ADDENDUM #1

December 10, 2025

Building Envelope 2025 PI/Bond Project –
Roof Replacement at Daniel Wright Elementary School
Dublin City School District Board of Education
150 W. Bridge Street
Dublin, Ohio 43017

Mays Project #: DOH43-013

Sheet No.:
A1.1

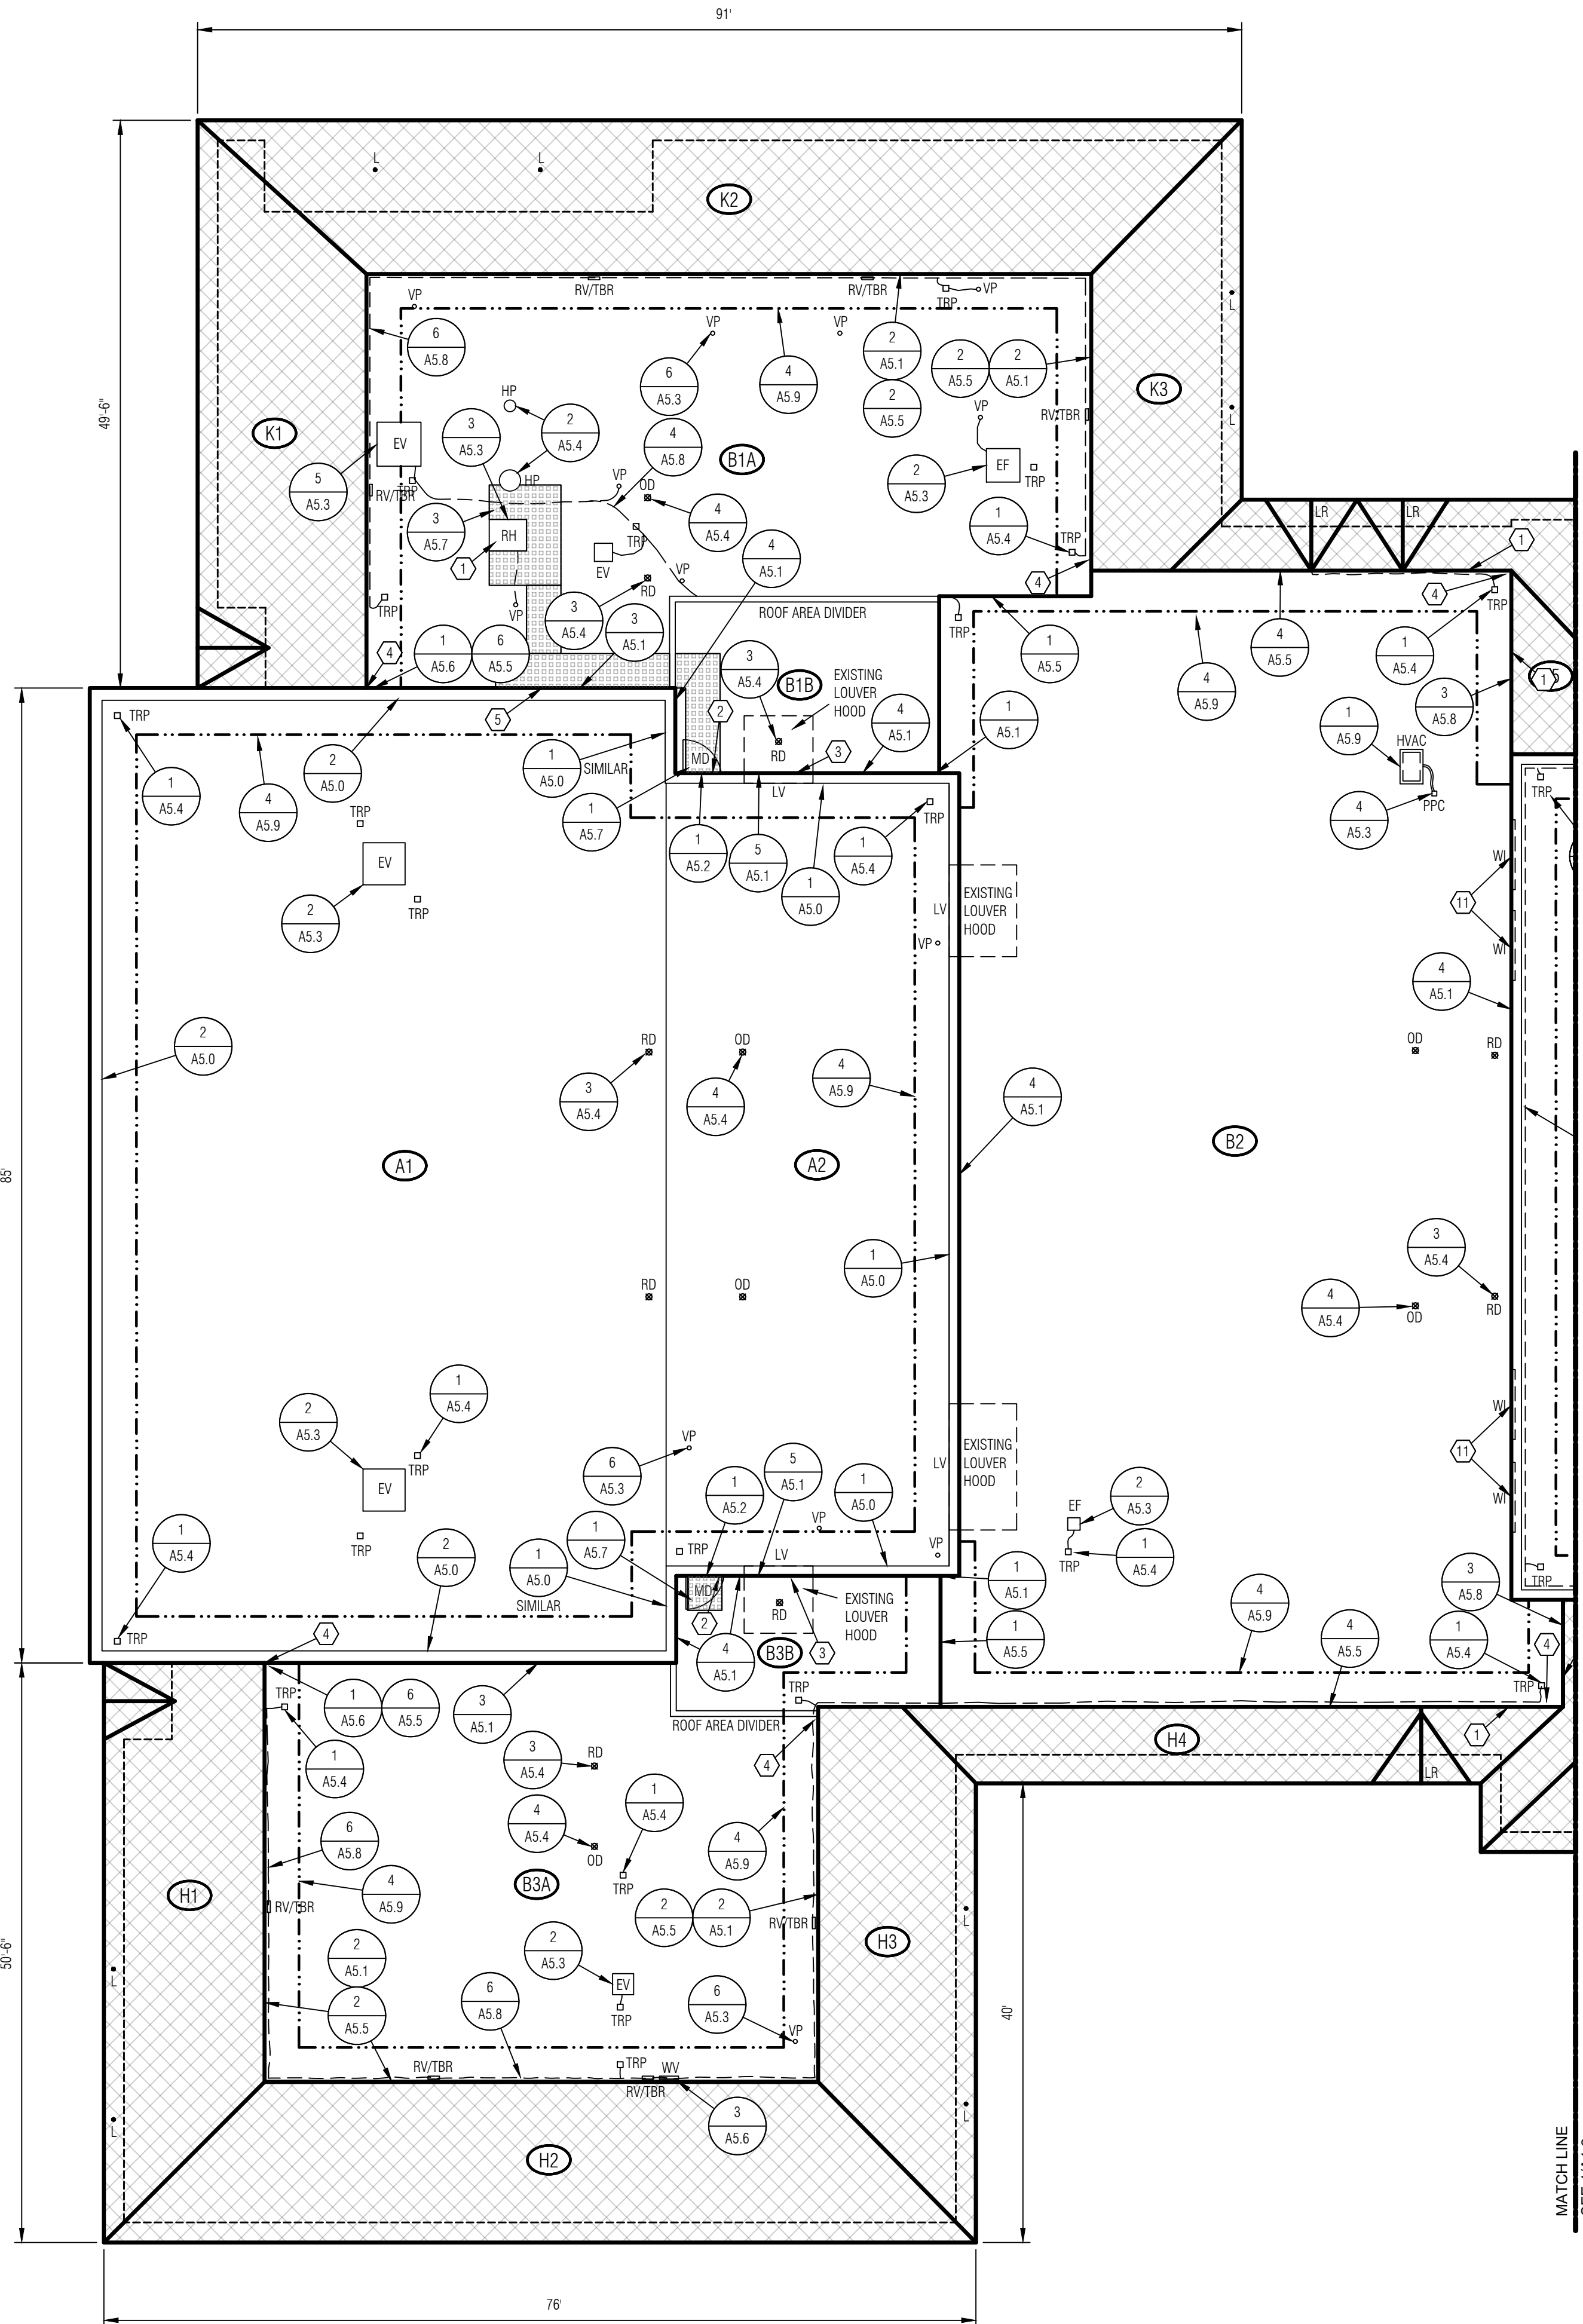
1. Clarified the estimate for Alternate #2.
2. Revised the EPDM membrane thickness to a nominal thickness instead of a minimum thickness.
3. Clarified aluminum-framed window warranty requirements.
4. Revised the aluminum windows to a fixed window instead of casement.
5. Deleted requirements for window screens on the aluminum windows.
6. The roof system composition for the new roof system on Roof Area F1 has been clarified.
7. Deleted requirements for a minimum height at the existing metal wall panels.

It appears Roof Area F1 is not part of any of the new roof assemblies listed on the drawings. What assembly should we assume for this roof area?

The composition of the new roof system for this roof area will be clarified in Addendum #1.

ROOF AREAS B2, C2 - C9, D2, F1, AND D4: (SEE DETAIL 2/A5.8 - ROOF ASSEMBLY #2) THERMOPLASTIC ROOF MEMBRANE (A) COVERBOARD (A) 2.5" POLYISOCYANURATE INSULATION (MA) 2.5" POLYISOCYANURATE INSULATION (LL) VAPOR RETARDER (LL) EXISTING STEEL ROOF DECK ROOF AREAS F2, F3, AND L3: THERMOPLASTIC ROOF MEMBRANE - TAN (A) COVERBOARD (A) 2.0" POLYISOCYANURATE INSULATION (MA) 1/2" WATER-RESISTANT GYPSUM SUBSTRATE BOARD (LL) 5/8" FRT PLYWOOD¹ ROOF AREAS H1 - H6, I1 - I3, J1, K1 - K5, L1, L2, M1 - M4 (ALTERNATE #1): ASPHALT SHINGLES SELF-ADHERING UNDERLAYMENT 5/8" FRT PLYWOOD ROOF DECKING EXISTING ATTIC SPACE ROOF AREAS G1 AND G2 (ALTERNATE #1): UNREINFORCED EPDM (A) COVERBOARD (A) 2.5" POLYISOCYANURATE INSULATION (MA) 2.5" POLYISOCYANURATE INSULATION (LL) VAPOR RETARDER (LL) EXISTING STEEL ROOF DECK	ROOF AREAS B2, C2 - C9, D2, F1, AND D4: (SEE DETAIL 2/A5.8 - ROOF ASSEMBLY #2) THERMOPLASTIC ROOF MEMBRANE (A) COVERBOARD (A) 2.5" POLYISOCYANURATE INSULATION (MA) 2.5" POLYISOCYANURATE INSULATION (LL) VAPOR RETARDER (LL) EXISTING STEEL ROOF DECK ROOF AREAS F2, F3, AND L3: THERMOPLASTIC ROOF MEMBRANE - TAN (A) COVERBOARD (A) 2.0" POLYISOCYANURATE INSULATION (MA) 1/2" WATER-RESISTANT GYPSUM SUBSTRATE BOARD (LL) 5/8" FRT PLYWOOD¹ ROOF AREAS H1 - H6, I1 - I3, J1, K1 - K5, L1, L2, M1 - M4 (ALTERNATE #1): ASPHALT SHINGLES SELF-ADHERING UNDERLAYMENT 5/8" FRT PLYWOOD ROOF DECKING EXISTING ATTIC SPACE ROOF AREAS G1 AND G2 (ALTERNATE #1): UNREINFORCED EPDM (A) COVERBOARD (A) 2.5" POLYISOCYANURATE INSULATION (MA) 2.5" POLYISOCYANURATE INSULATION (LL) VAPOR RETARDER (LL) EXISTING STEEL ROOF DECK
